Request For Information

RFI-068

Subject: BP3 Prom Drain Locations
Project: Steamboat - BV BP Promenade and Goldwalk
Address: 2305 Mount Werner Circle
Steamboat Springs CO 80487 USA
Phone:
To: Zach Ray
MTech Mechanical Technologies Group, Inc.
From: Saunders Construction, LLC Alec Hallman

1A-C.300

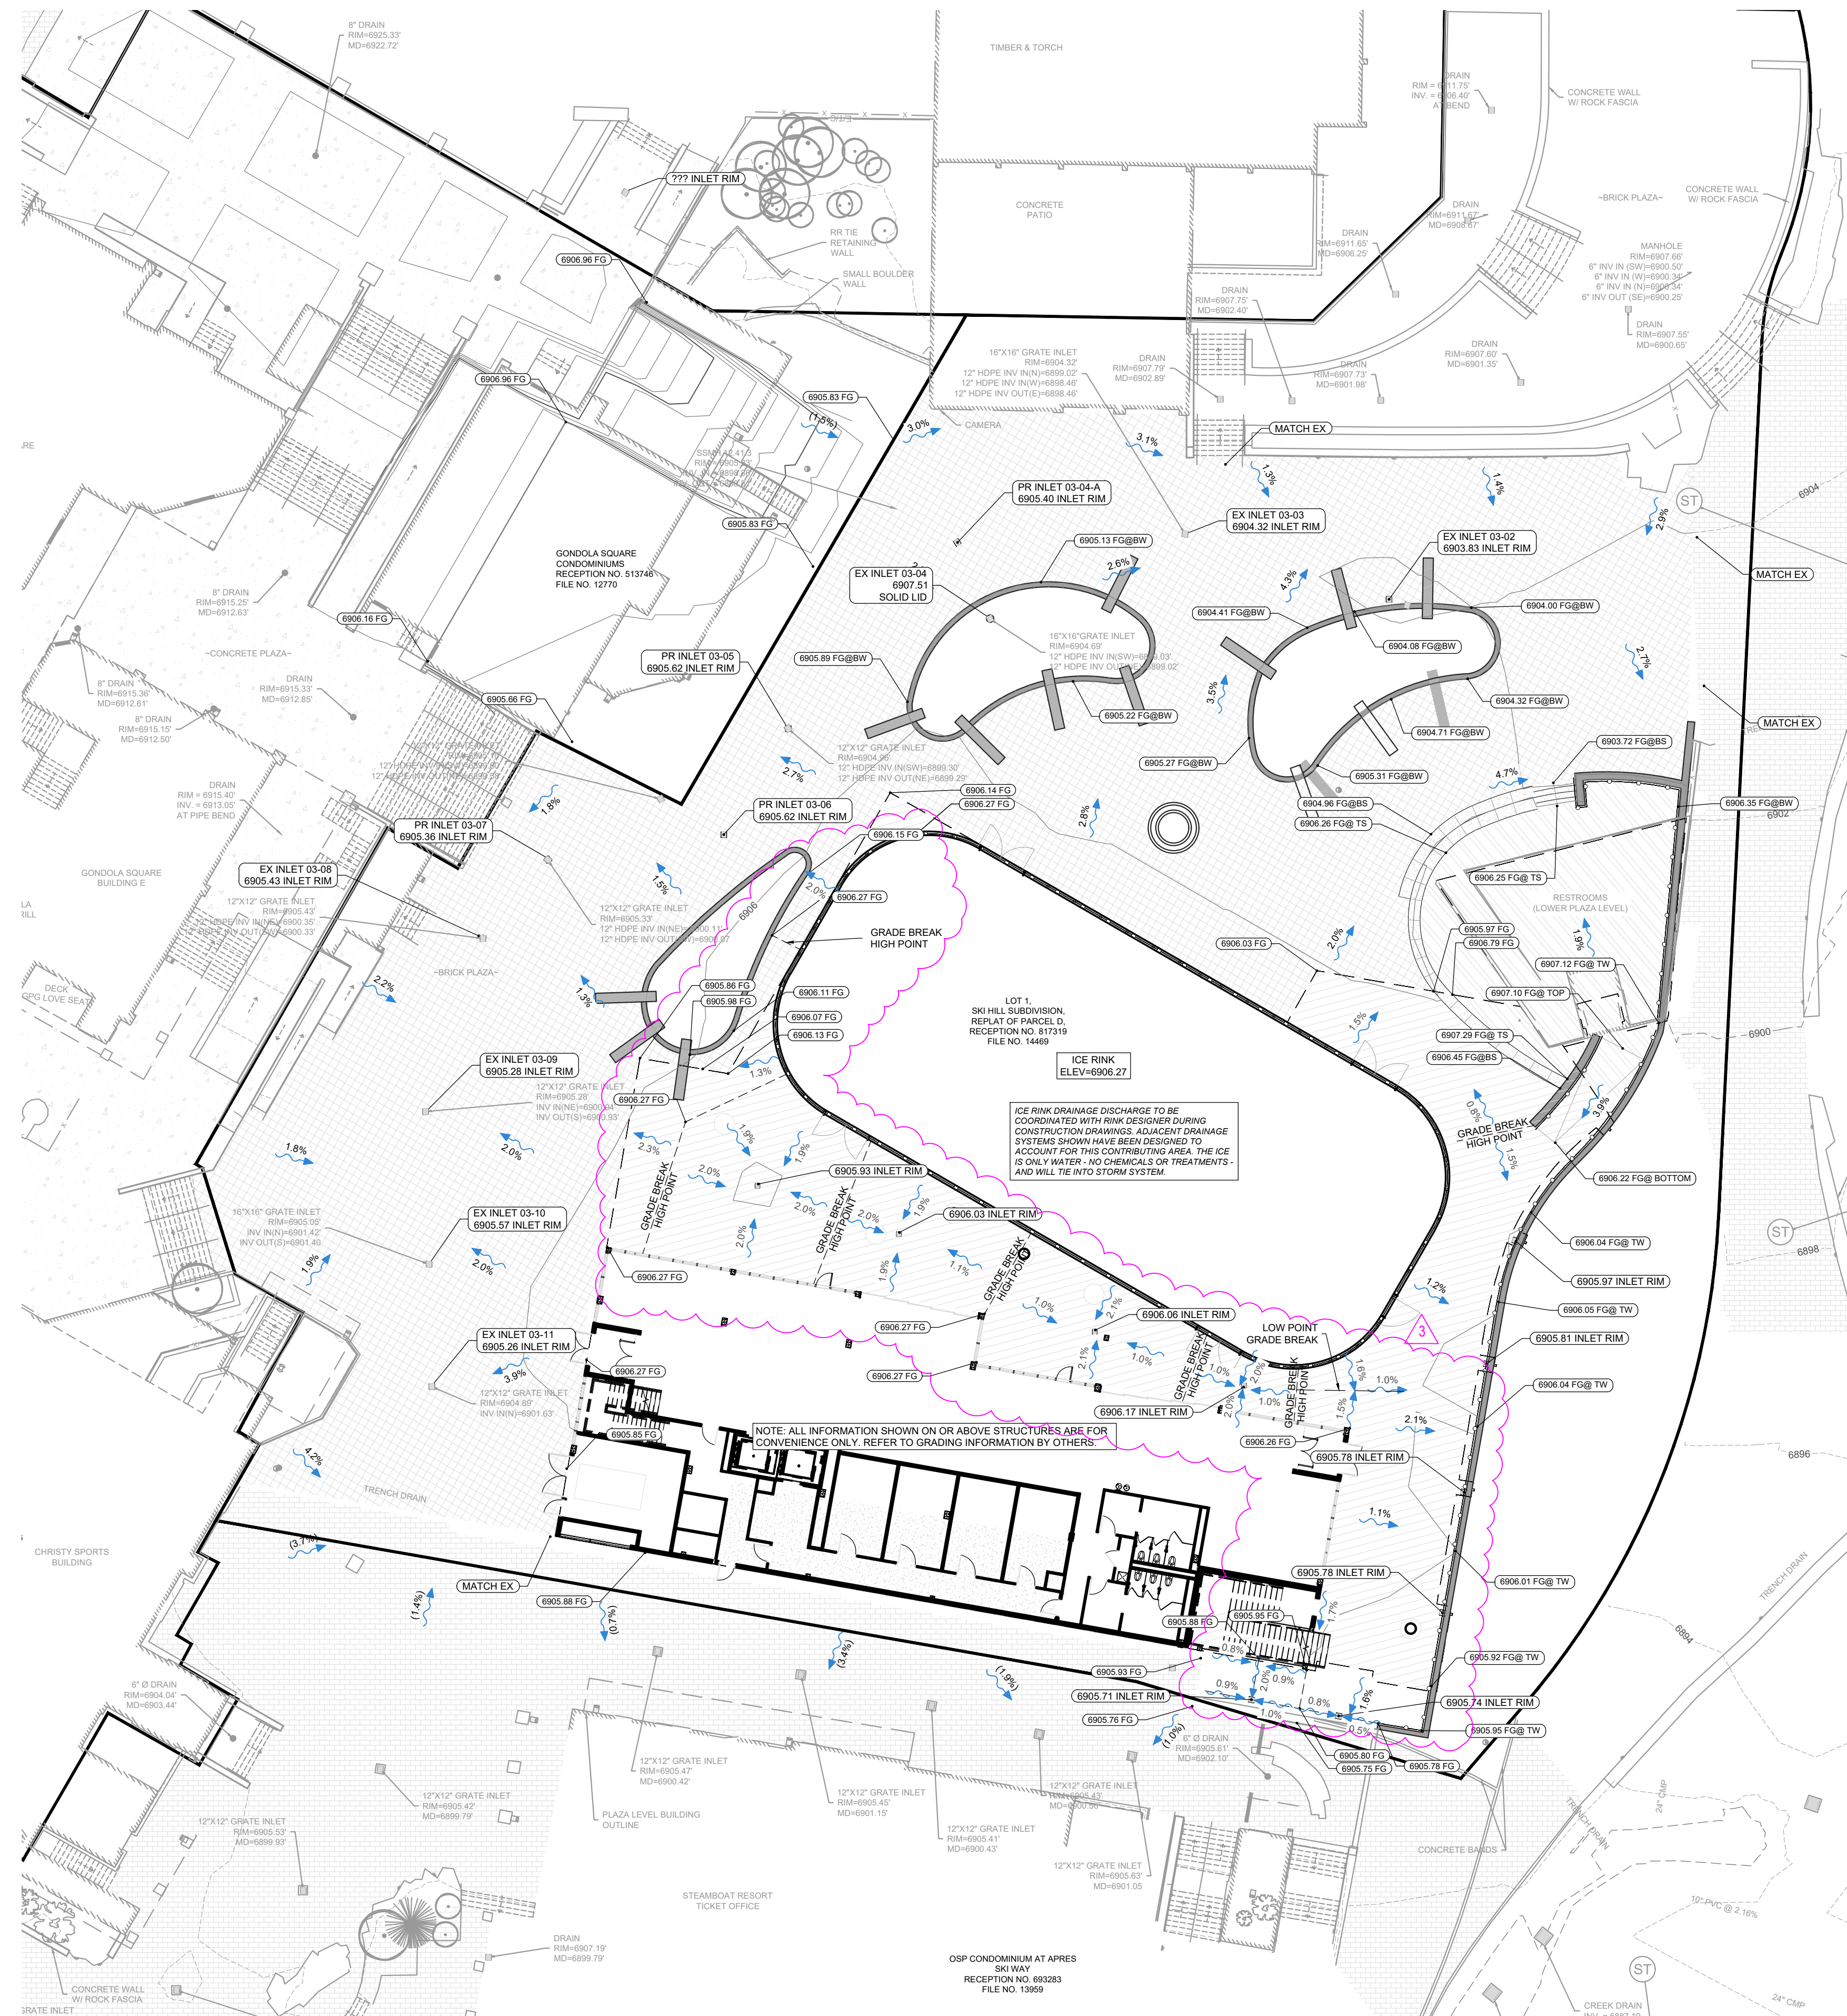
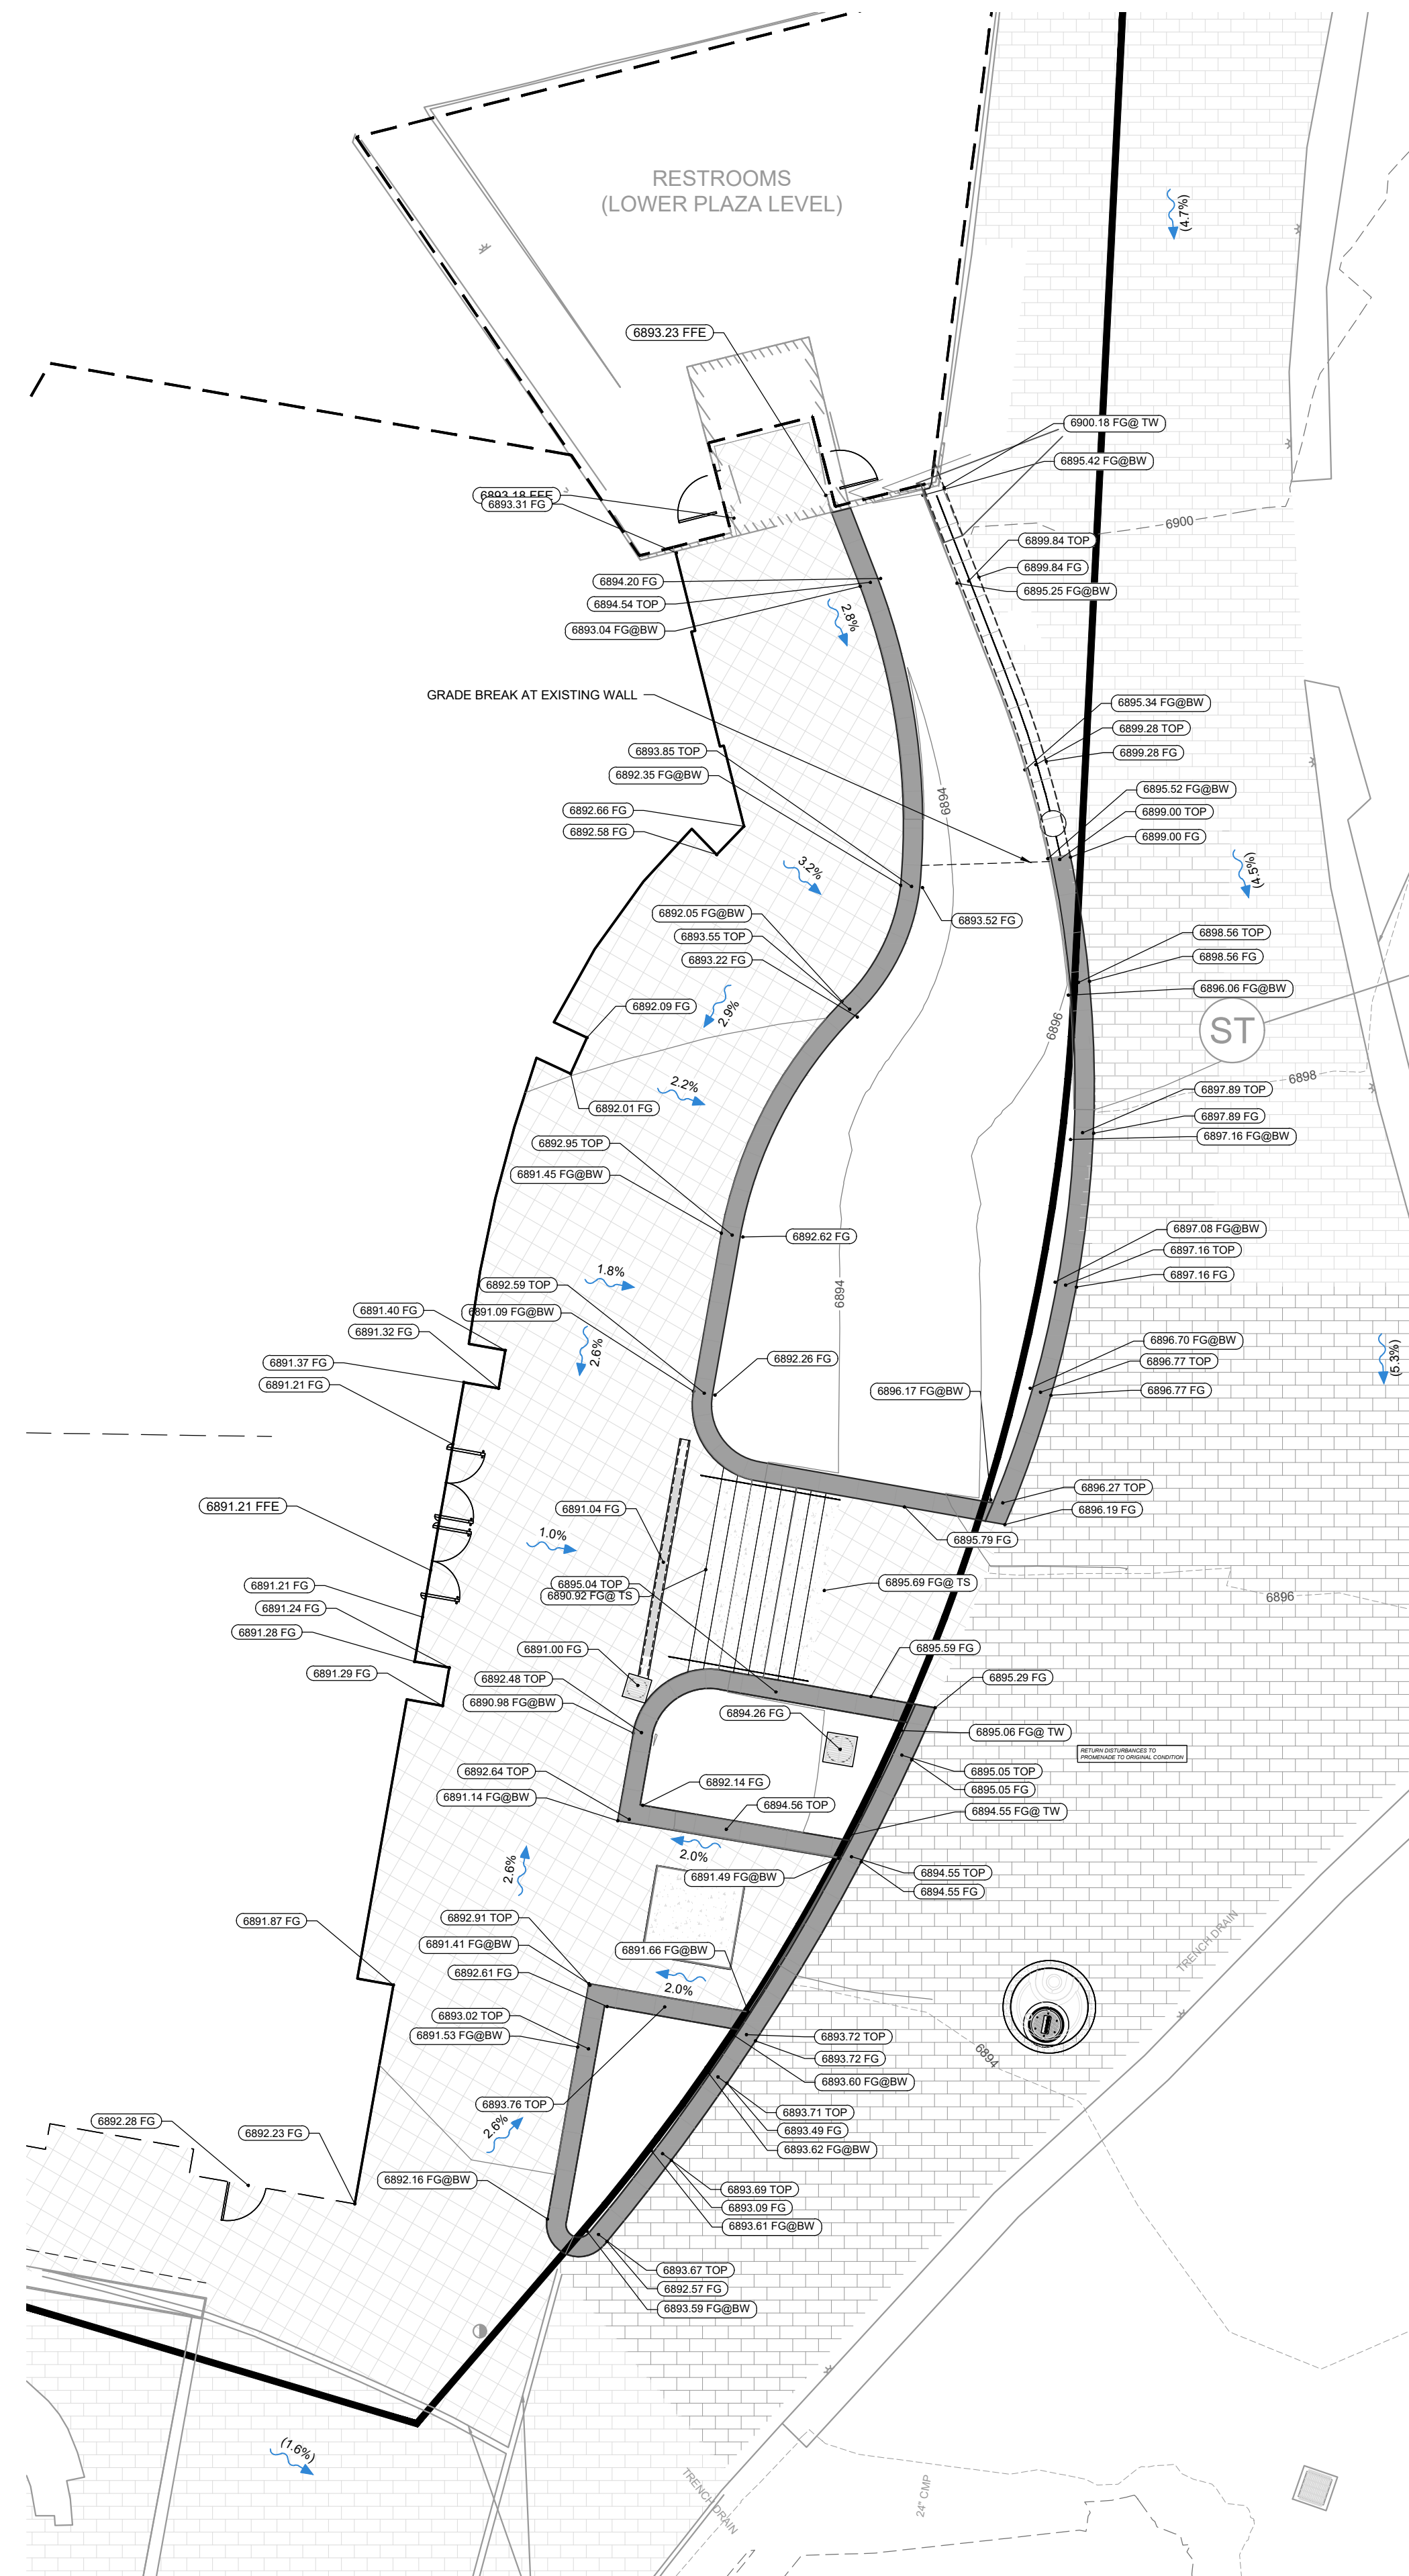
Ref attached correspondence, the plaza drain locations and associated piping need to be updated.

Please advise changes at plaza drain locations.

DRAIN LOCATIONS HAVE BEEN REVISED PER UPDATED PLAZA BUILDING FOOTPRINT. DIMENSIONS FOR DRAIN LOCATIONS ADDED TO A1-A1.201. ONE DRAIN ADDED AT PINCH POINT BETWEEN ICE RINK AND PLAZA SLAB. ONE DRAIN REMOVED FROM PROMENADE ROOF ALONG EAST PROMENADE WALL AND ONE RELOCATED SLIGHTLY FURTHER NORTH (TO AVOID ELECTRICAL ROOM). TWO DRAINS ADDED ON SOUTH SIDE NEAR OSP TO FACILITATE REMOVAL OF DRAINS ABOVE ELECTRICAL ROOM. ASSOCIATED PIPING REVISED. SOME UNDERGROUND PIPING REMOVED UNDER ELECTRICAL ROOM. A NEW SHEET (1A-A1.201P) ADDED TO SET FOR CLARITY ON PLAZA SLOPES.

1A-C.300 - OVERALL GRADING PLAN - UPDATED GRADING AND DRAIN LOCATIONS
1A-C.301 - SEGREGATED GRADING PLAN - UPDATED GRADING AND DRAIN LOCATIONS
1A-A1.201 - PROMENADE - CONSTRUCTION PLAN - LEVEL 01 - UPDATED DRAIN LOCATIONS, ADDED ONE DRAIN IN PLAZA BUILDING SLAB THAT WAS SHOWN ON PLUMBING BUT NOT ARCHITECTURE (UNDER FUTURE STAIR)
1A-P1.199 - PROMENADE - PLUMBING UNDERGROUND PLAN - LEVEL 00 - REVISED ASSOCIATED PLUMBING
1A-P1.200 - PROMENADE - PLUMBING PLAN - LEVEL 00 - UPDATED DRAINS AND PLUMBING
1A-P1.201 - PROMENADE - PLUMBING PLAN - LEVEL 01 - UPDATED DRAINS AND PLUMBING
